**FINAL DRAINAGE REPORT
FOR
HOMESTEAD NORTH AT STERLING RANCH FILING NO. 1
EL PASO COUNTY, COLORADO**

**September, 2022
Project No. 25188.00**

**PCD Filing No.:
SF22-13**

Inlet 2D

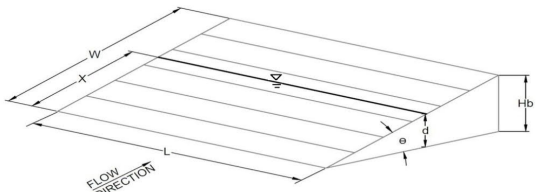
are these correct?
